5249 California Ave SW, Seattle, WA

EDG RESPONSE | Design Process Review

EDG RESPONSE | Priorities & Board Recommendations

OPTION 2:

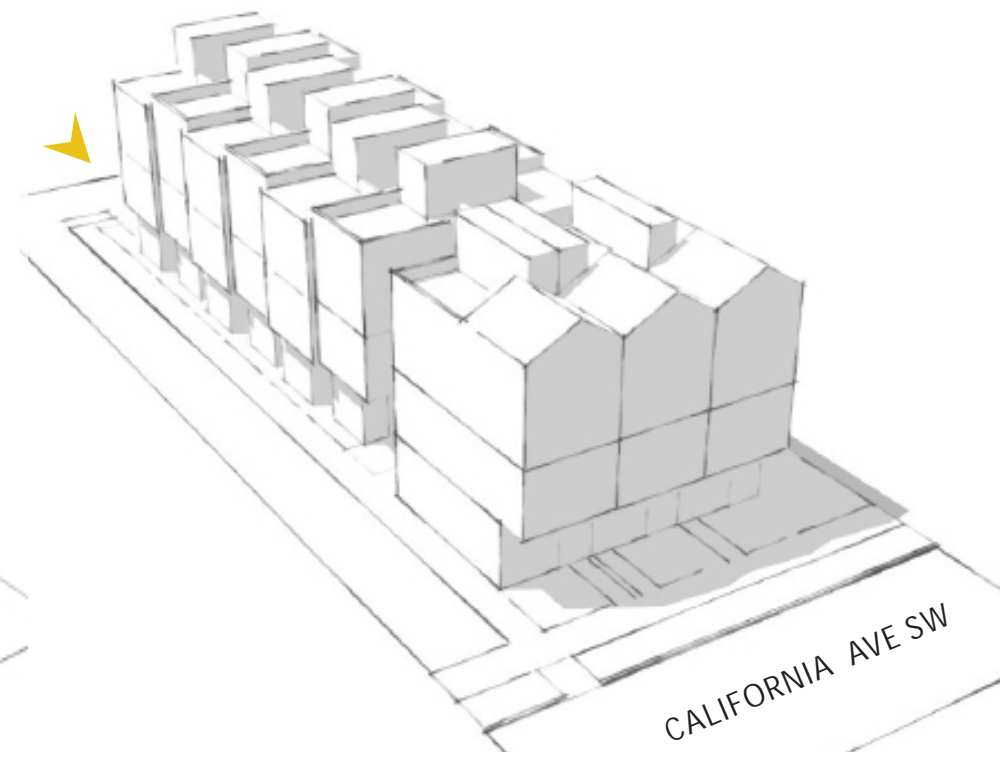
a. Staff appreciates the applicant has proposed two massing options with a north/south orientation to prioritize providing natural light and ventilation to the townhouse units. (CS1-B)

b. The site is somewhat exposed given its lower scale surroundings and frontage along California Avenue SW. Therefore, in addition to the following guidance, staff recommends the applicant proceed in design development with massing option 2, which breaks the project up into two buildings. Breaking up the buildings reduces the bulk of the structure and provides a better relationship to the surrounding scale and context. Additionally, massing option 2 minimizes solid waste impacts to residents and visitors while making a stronger connection to the street by placing more units along street. (CS2-C-2, CS2-D-4, DC1-C-4, DC2-A-2)

c. Staff supports the internalized stair and penthouses in massing option 2 to push bulk and mass away from California Avenue SW as well as the buildings' edges. (DC2-A-2)

Response: The recommended massing option – massing option 2 on pg. 11 – was developed to further take advantage of natural light and ventilation via extensive fenestration and operable windows on the north and south facades.

Response: The design team moved forward with massing option 2.

Response: Penthouses for the west structure remain internalized. The east structure was modified to four stories without a penthouse. The fourth story is set back from California Ave SW to push bulk away from the street.

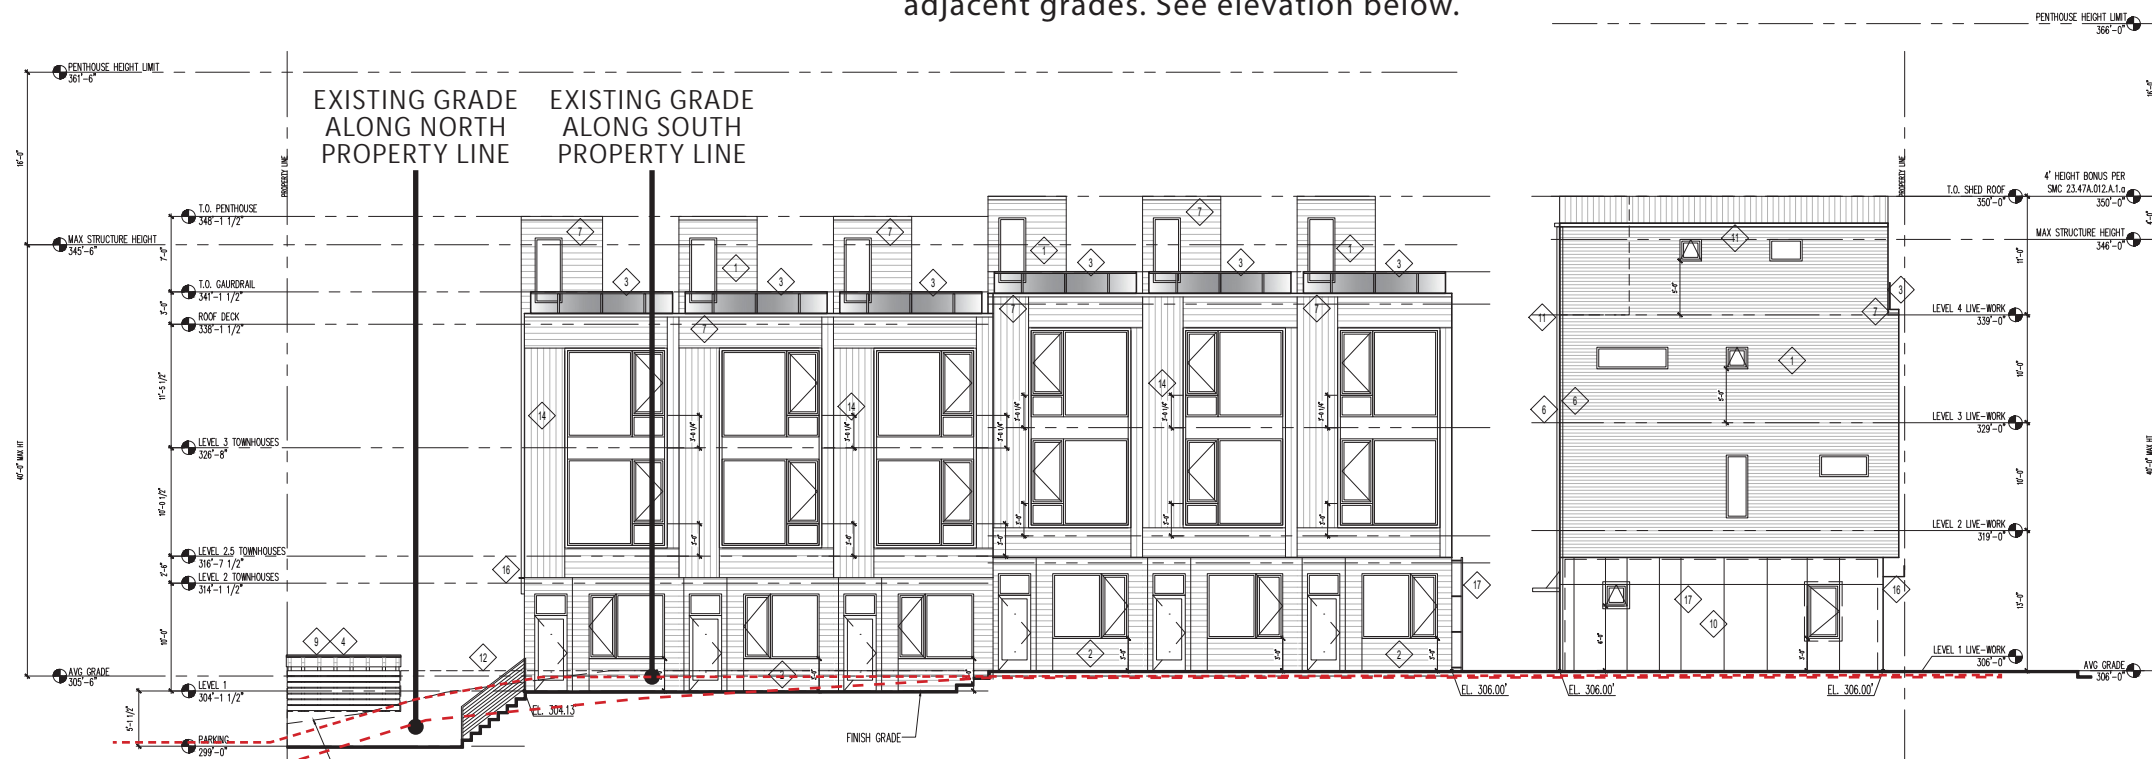
a. The site slopes downward roughly ten feet to the west toward the alley. It is not clear from the applicant's ADR EDG packet if the units will be stepping with grade and Staff is concerned with their relationship to the site topography. Clearly demonstrate the buildings' relationship to grade in the Master Use Permit plans and step the units as necessary to accommodate changes in elevation. (CS1-C-1)

Response: The westernmost three townhouse units are stepped down slightly from the townhouse units to the east and live-work units. The parking lot and solid waste storage adjacent to the alley are approximately level with the alley – several feet below the structures. This configuration addresses the adjacent site context because the lots to the north and south are fairly flat, and then drop off steeply to the alley at the west end of the site. This prevents the western units from dropping too far below the adjacent grades. See elevation below.

MAIN LEVEL

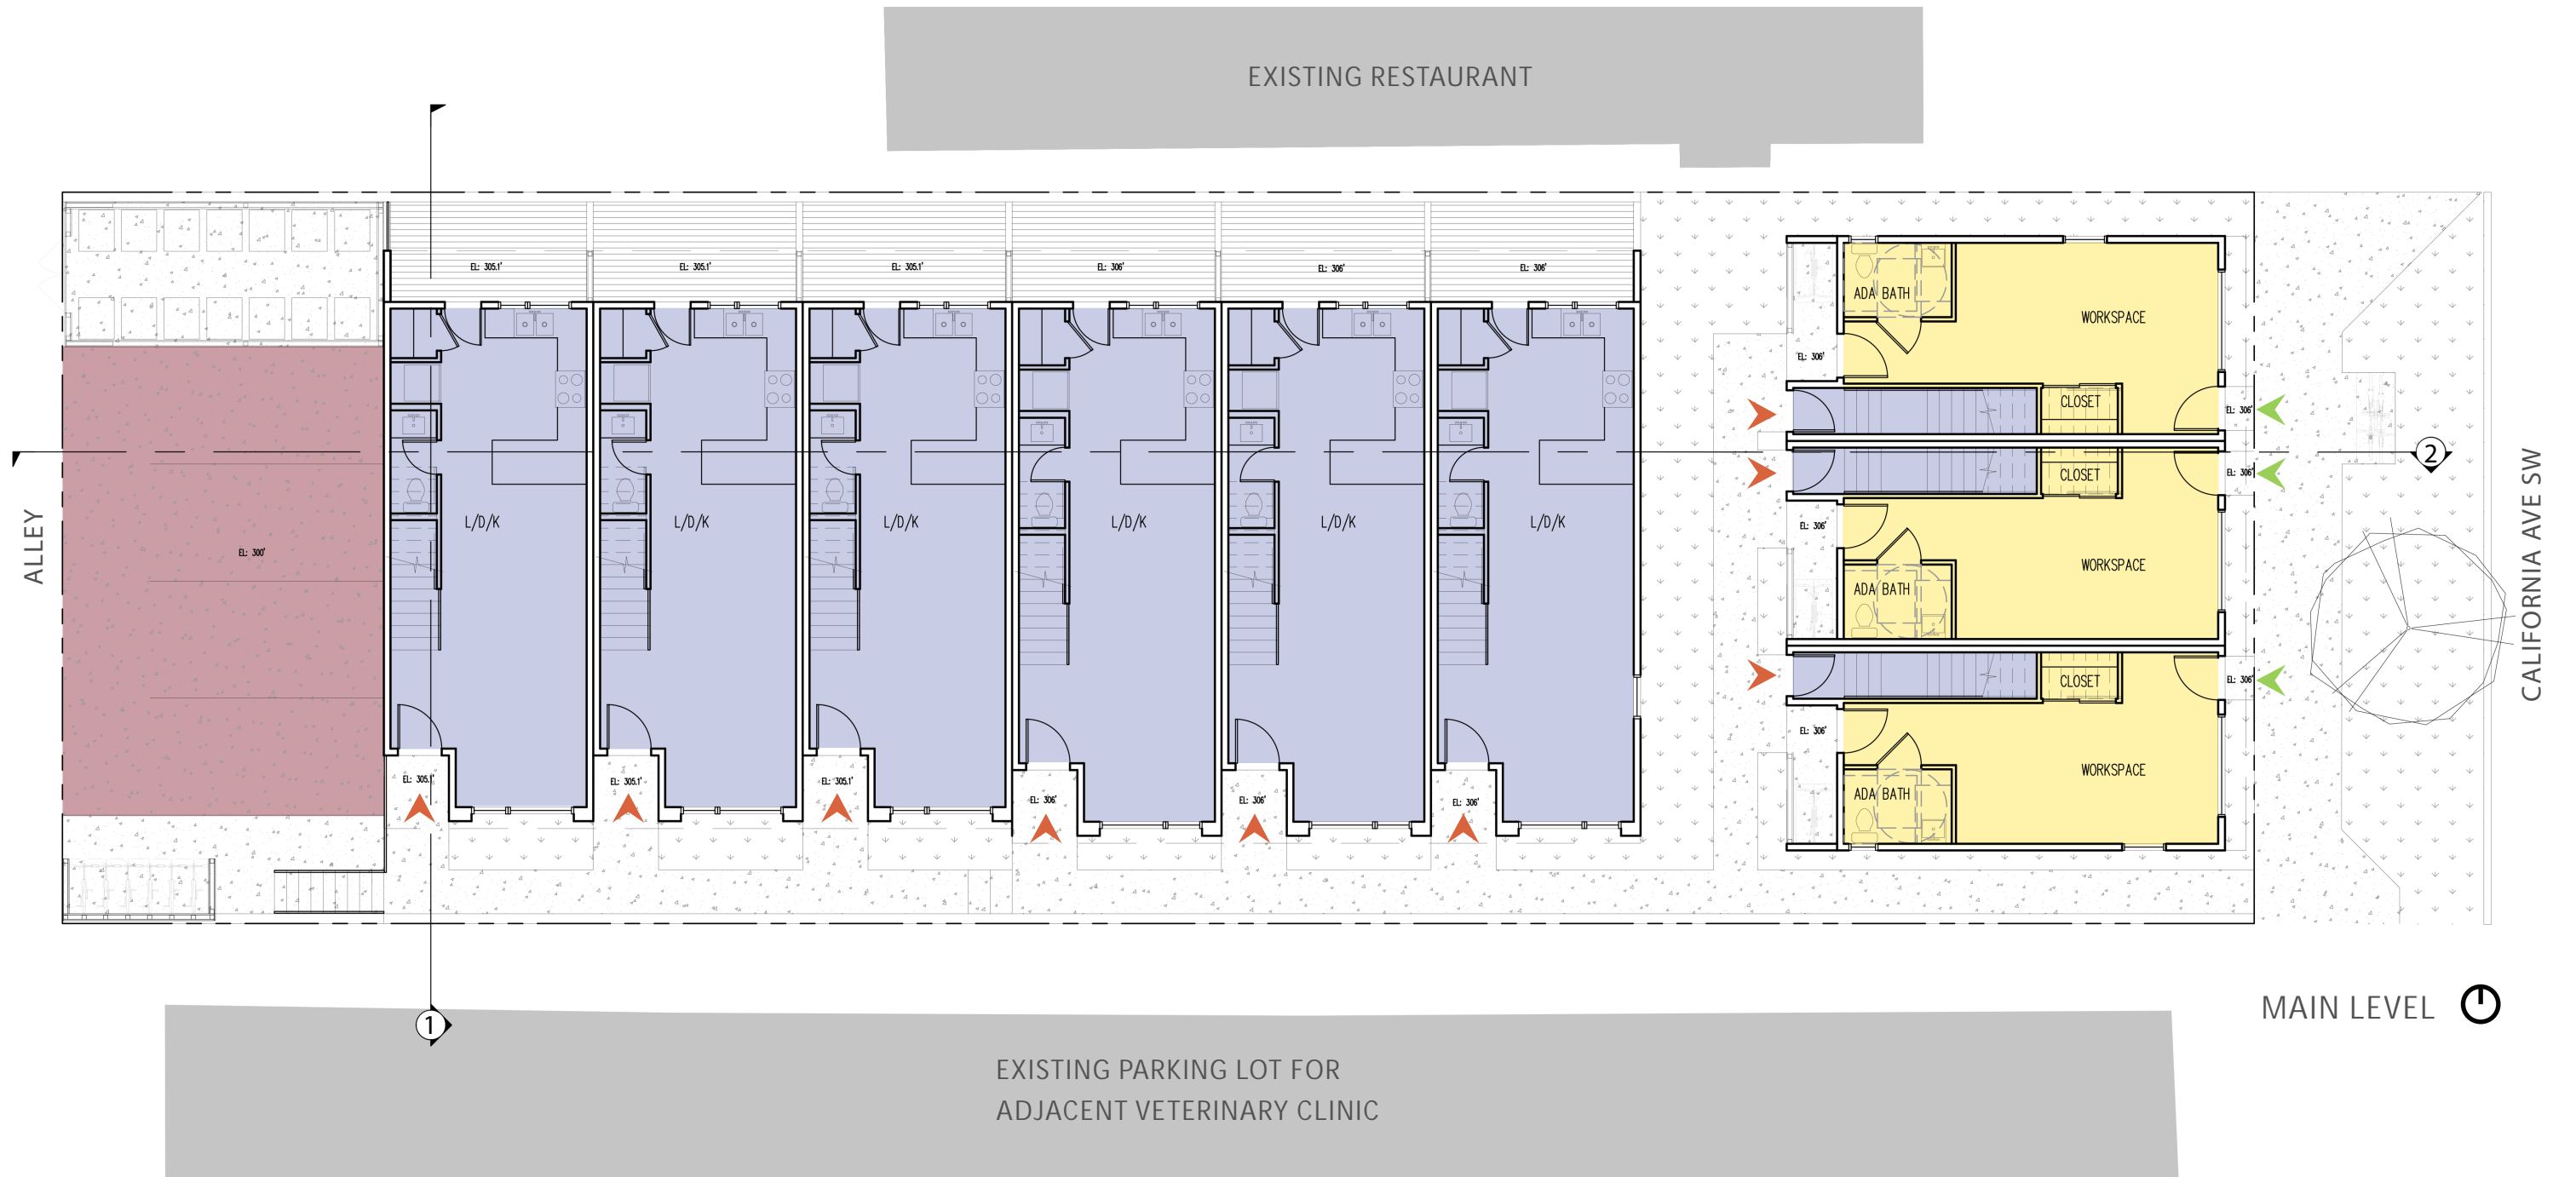
a. Staff recommends prioritizing several wayfinding strategies and design features to provide clear guidance for residents, guests, and deliveries particularly from California Avenue SW and the alley to rear and street facing units. (PL2-D-1)

b. Staff questions whether two pedestrian paths along the north and south property lines are necessary. Providing one main entry path to the front doors and private rear yards gives more usable space to each of the units and clarifies wayfinding to units. (PL2-D-1, DC3-A, DC3-B)

Response: Wayfinding to residential units is made simple by providing just one main sidewalk to all numbered unit entries at the south of the structure. The sidewalk does extend partially to the north to accommodate the separate entries to the residential portions of the live-work units. Pathway lights illuminate the way to all residential entries. Entries to workspace portions of the live-work units will include commercial signage on the façade along California Ave SW and are clearly visible from the sidewalk.

Response: Design team edited the site plan to reflect the above recommendation.
